UFP SITE BUILT

TRUSS: A2
JOB ID: 72500235
DELIVERY DATE: 3/20/2025
REPAIR JOB ID: 72500235REP1
REPAIR DELIVERY DATE: 4/25/2025

SUBDIVISION/MODEL: DUNCANS CREEK
LOT #: 32

REPAIR ID: 0026134 (ATTACHED)

Job	Truss	Truss Type	Qty	Ply	PBS\HANOVER TRADITIONAL W/CAFE
72500235REP1	A2	Truss	4	1	Job Reference (optional)

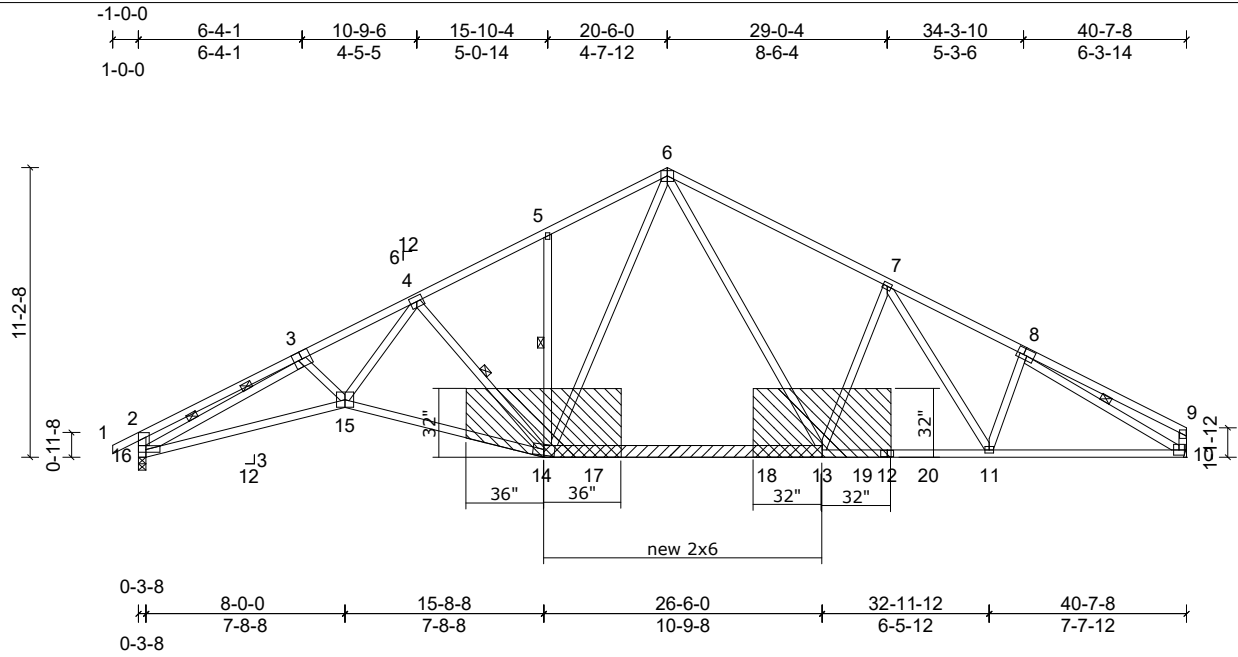
Repair to replace section of bottom chord as shown.

Cut and fit tight a new 2x6 SP or SPF No.2 as shown.
attach 1/2" Plywood or 7/16" OSB (APA Rated Sheathing Exposure 1) gusset
to both sides of truss as shown with two rows of 10d (.131" x 3") nails
spaced 4" oc in all members from each face, driven through both sheets of plywood.
